Project	IEEE 802.16 Broadband Wireless Access Working Group < http://ieee802.org/16 >	
Title	MAC Messages supporting the CSI	
Date Submitted	2006-11-12	
Source(s)	Wu Xuyong, Huawei Huawei Industrial Base, Bantian, Longgang, Shenzhen 518129 P.R.C	Voice: +86-755-28972327 Fax: wuxuyong@huawei.com
Re:	80216h-06_059: IEEE 802.16 Working Group Working Group Letter Ballot #24 (2006-10-11)	
Abstract	Discuss the MAC messages supporting the CSI, such as DCD, DL-MAP etc.	
Purpose	To consolidate the working document.	
Notice	This document has been prepared to assist IEEE 802.16. It is offered as a basis for discussion and is not binding on the contributing individual(s) or organization(s). The material in this document is subject to change in form and content after further study. The contributor(s) reserve(s) the right to add, amend or withdraw material contained herein.	
Release	The contributor grants a free, irrevocable license to the IEEE to incorporate material contained in this contribution, and any modifications thereof, in the creation of an IEEE Standards publication; to copyright in the IEEE's name any IEEE Standards publication even though it may include portions of this contribution

Proposed changes on figure-h14 and h15

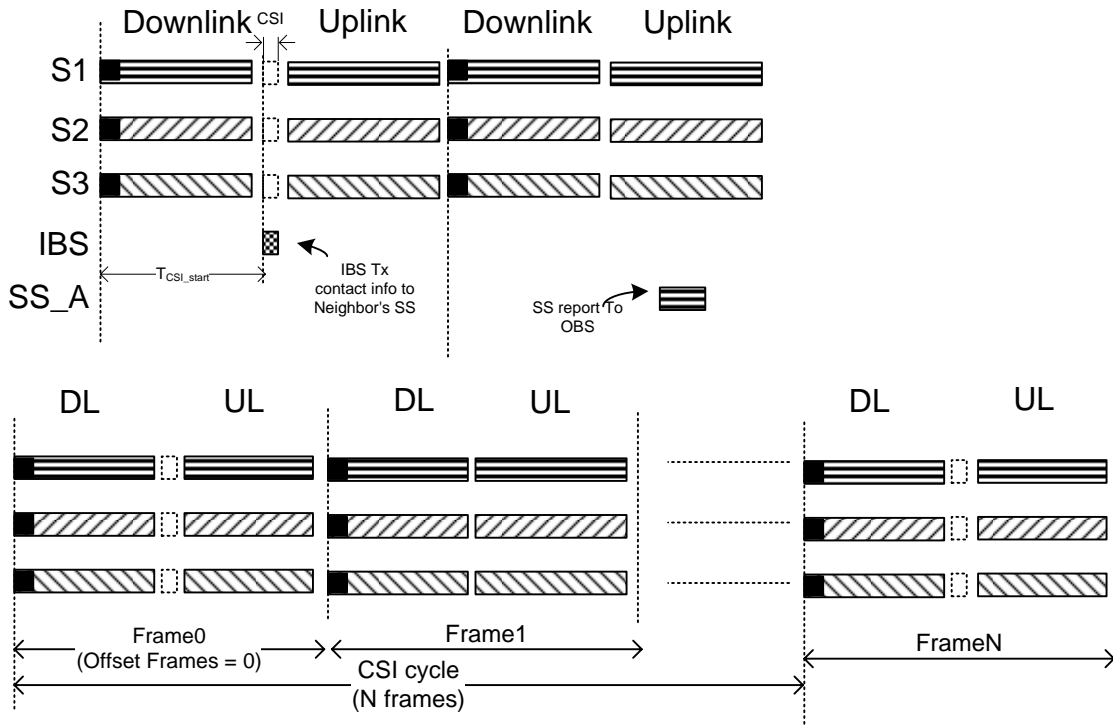
Proposed changes on figure-h29 and h30
